PIERGIORGIO BERUTO
ANTONIO ORZELLI

IEEE 802.3cg
PLCA CRS generation
September 10th, 2018

current draft 2.0

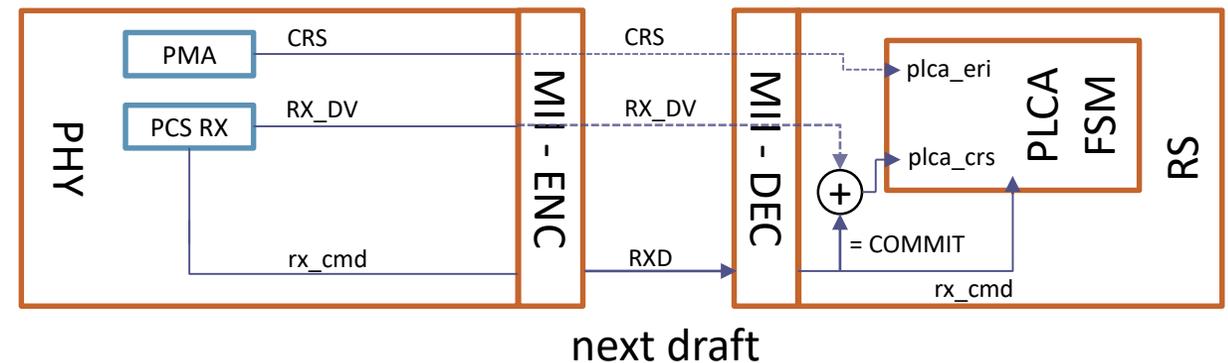
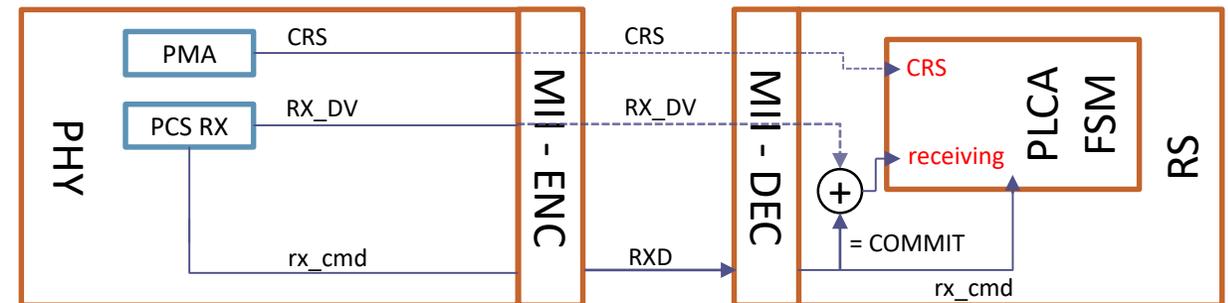
- 10BASE-T1S PHY generates CRS as the logical OR of 'transmitting' and 'receiving' PCS variables
 - asserted when a COMMIT or packet preamble is detected
- According to comment #649 this way of generating CRS, although used in other standards (e.g. 100BASE-X), is not suitable for an half-duplex multidrop PHY
 - CRS should be generated based on energy detection instead

- CRS generation does not change at all the way PLCA works
 - the information PLCA needs is still available, it just need to be encoded differently
- This can be done with a simple variable substitution
 - $plca_eri \leftarrow CRS$
 - CRS being asserted on energy detection is ERI by definition!
 - $plca_crs \leftarrow RX_DV + (rx_cmd = COMMIT)$
 - $plca_crs$ can be deduced from RX_DV (valid packet) or when receiving a $COMMIT$, by definition

$plca_eri$ is now generated from CRS directly

$plca_crs$ is now decoded in the RS from RX_DV and rx_cmd

- plca_eri renamed to “CRS”, to avoid confusion
- plca_crs renamed to “receiving” to avoid confusion
- Proposed text changes can be found in the following documents, marked with #649
 - http://www.ieee802.org/3/cg/public/Sept2018/beruto_04_CI_148_d2p0_proposed.pdf
 - http://www.ieee802.org/3/cg/public/Sept2018/beruto_03_CI_147_d2p0_proposed.pdf
 - http://www.ieee802.org/3/cg/public/Sept2018/beruto_01_CI_22_d2p0_proposed.pdf
